Plan Commission

Monday, March 25, 2019

SUBJECT: Recommendation regarding a Precise Implementation Plan (PIP) for 428 N. Superior Street (Parcel ED-477). Submitted by Joel Ehrfurth, Mach IV Engineering & Surveying, authorized representative for Irwin School Development LLC, property owner.*

REQUESTED ACTION:	Precise Implementation Plan (PIP) Required follow up to General Plan and Rezoning approvals granted in 2018.
COMMON DESCRIPTION:	428 N. Superior Street, also known as the Irwin School Property.
PARCEL NUMBER:	ED-477
EXISTING ZONING:	R-3 PDD (General Business District with a Planned Development District overlay)
SURROUNDING LAND USES:	R-2 Residential to the north, south, east, and west.
COMPREHENSIVE PLAN:	Commercial

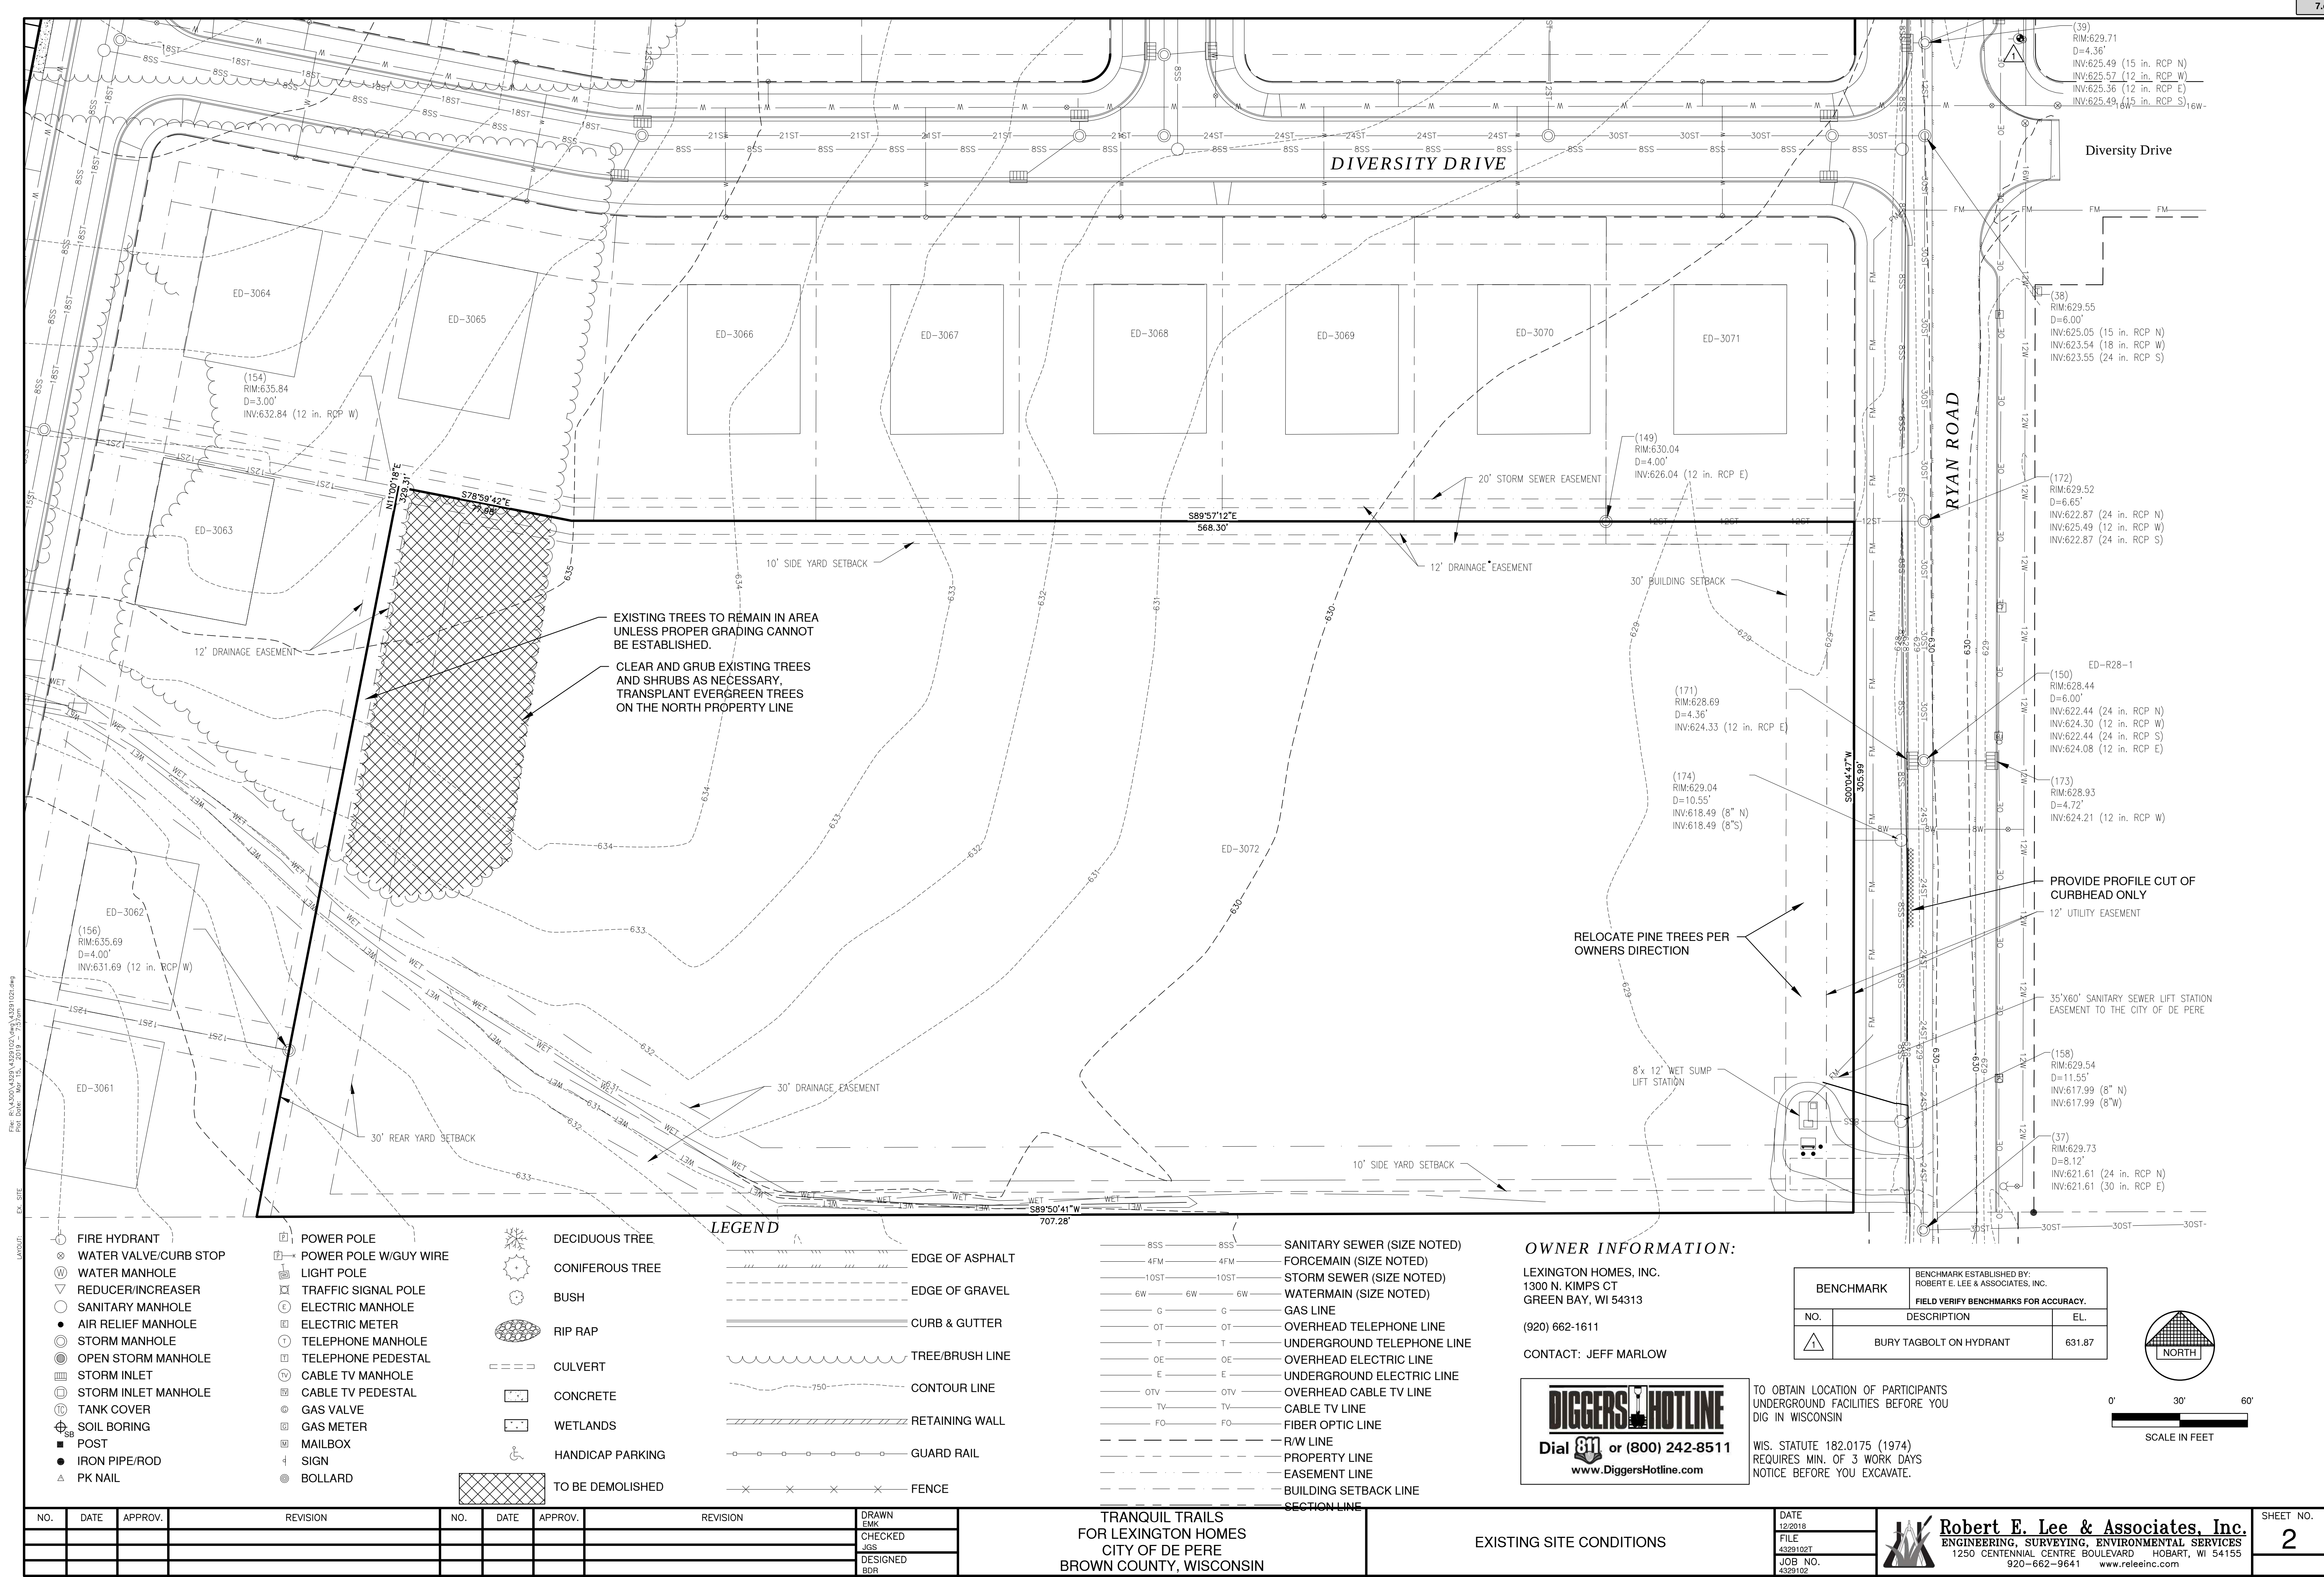
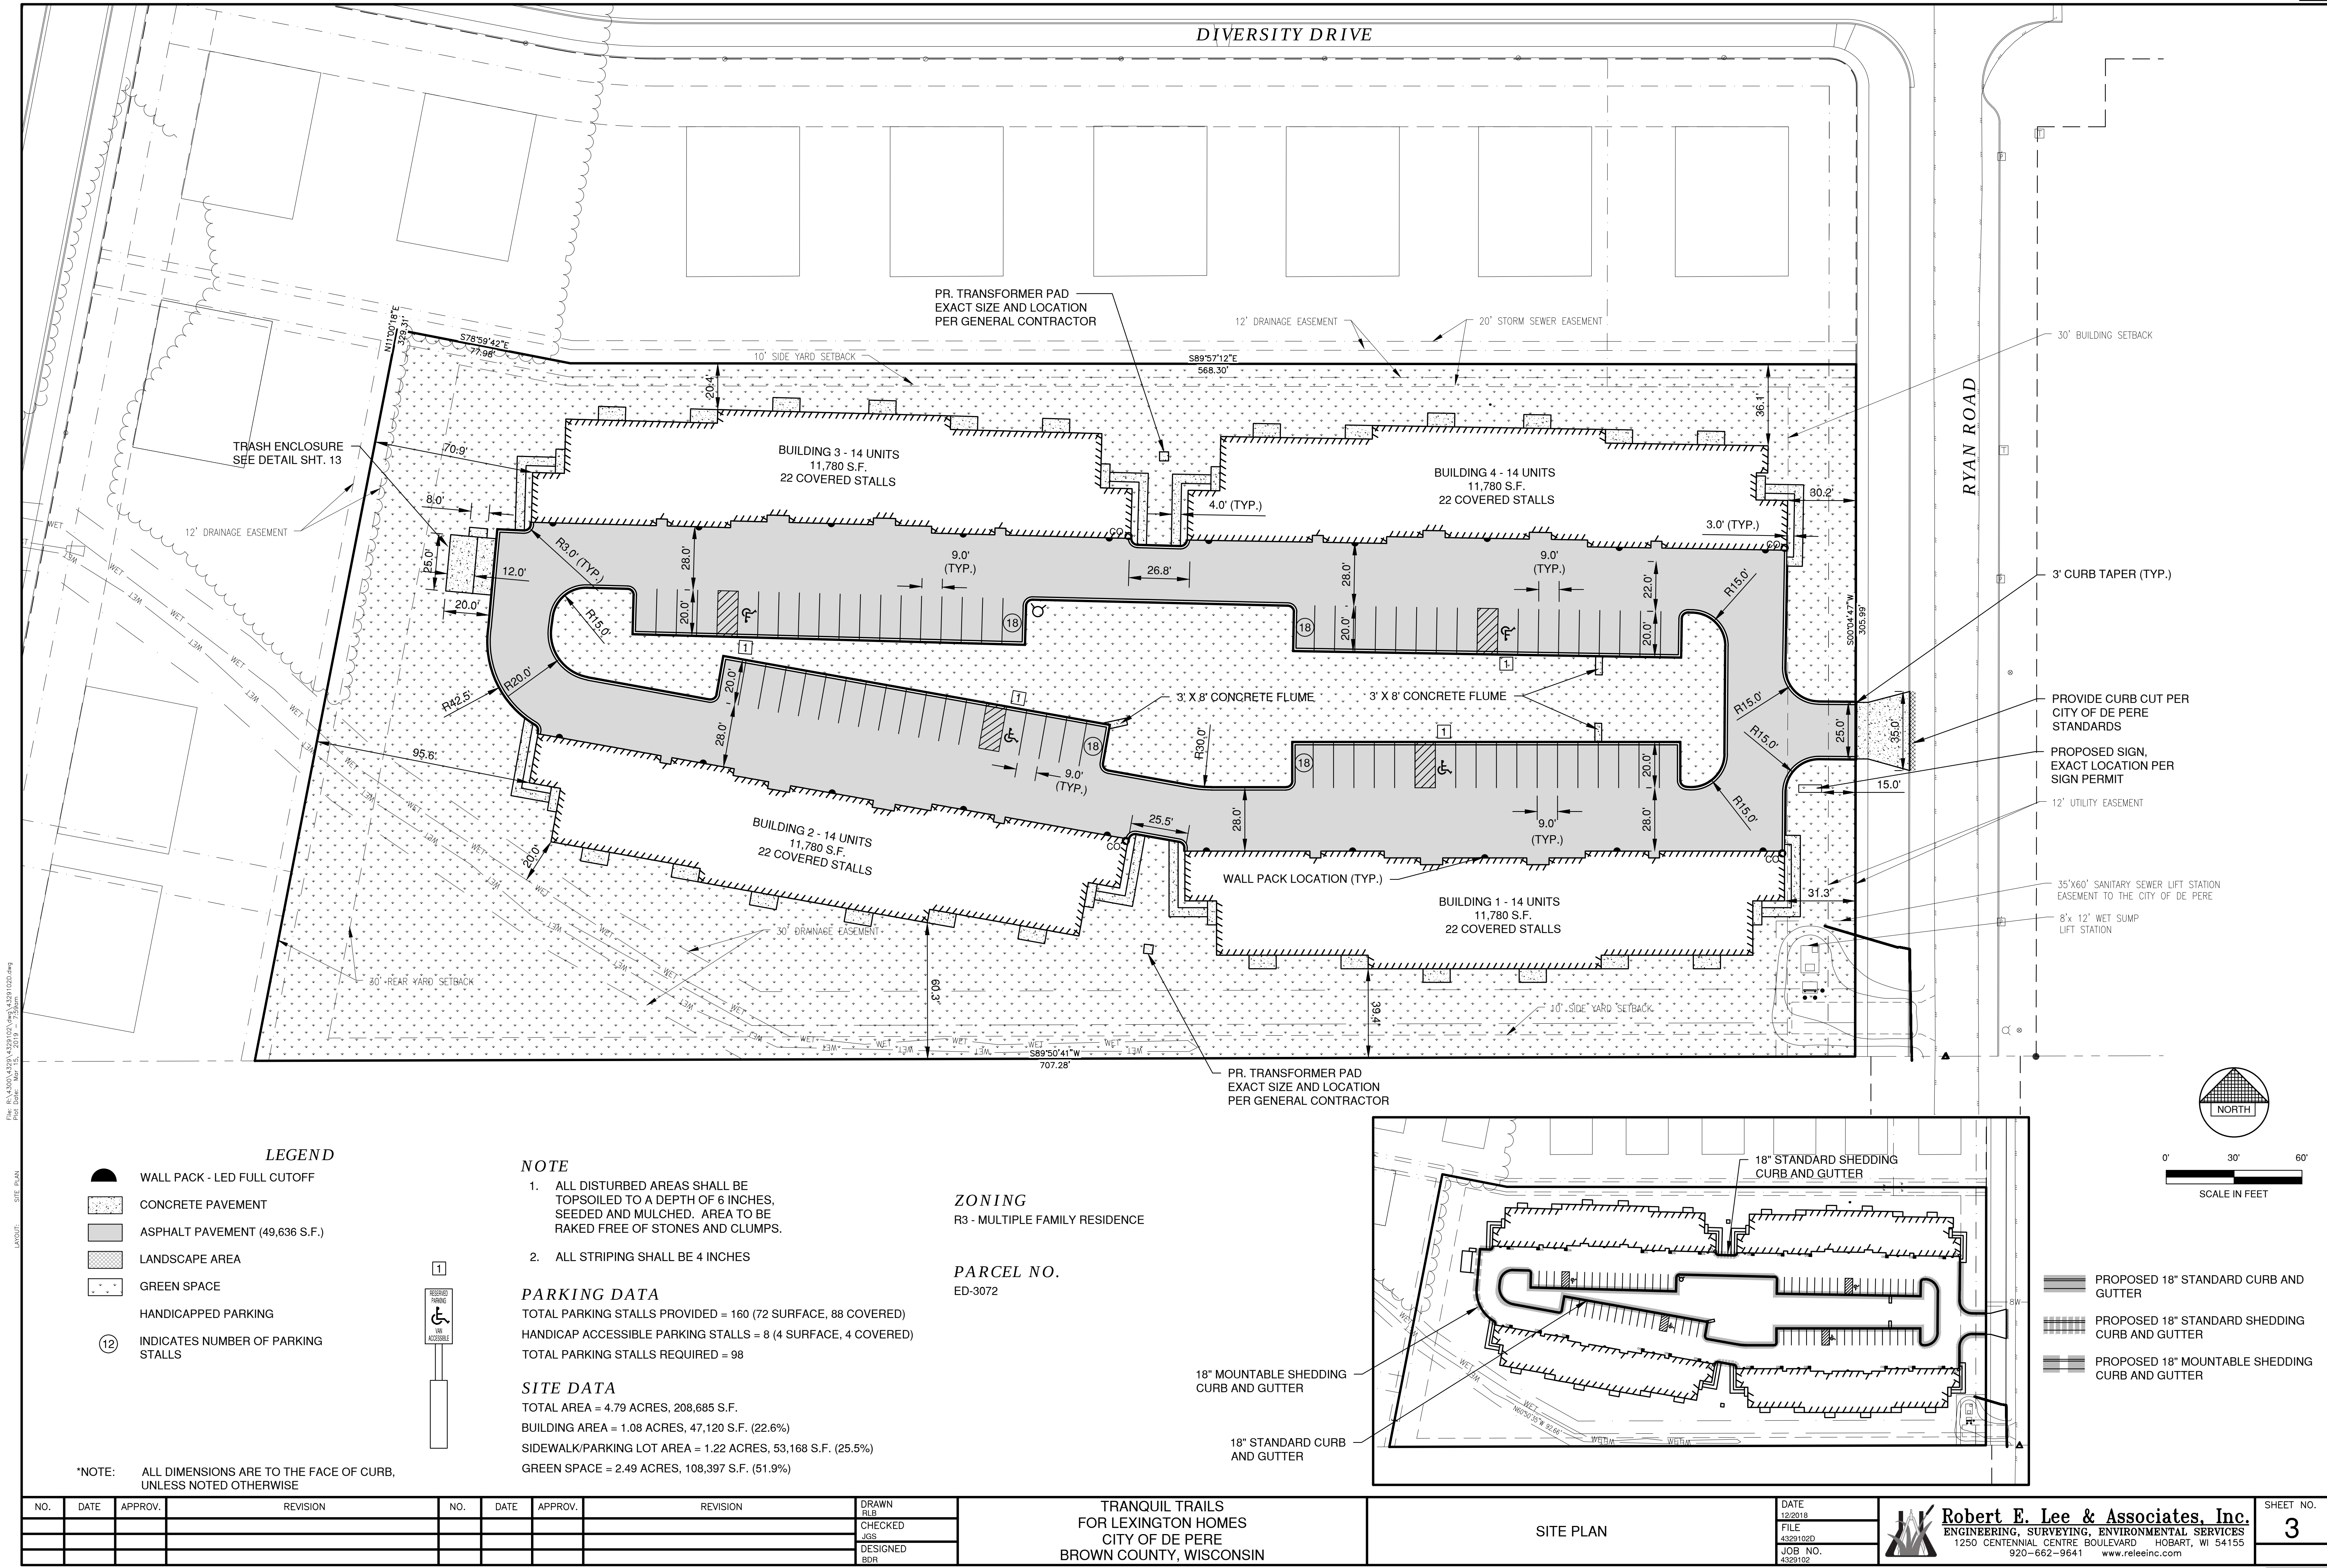
1. Sign was moved back to 15' off ROW (Sheet 3-7)
2. Photometric Plan is included at the end
3. Refuse Center Detail updated (Sheet 13)
4. Landscaping plan Updated, Tree symbols added to West property line, Jared will address 90% impervious at the meeting as needed
5. Callout added to keep existing trees unless proper grading cannot be established (Sheet 2)
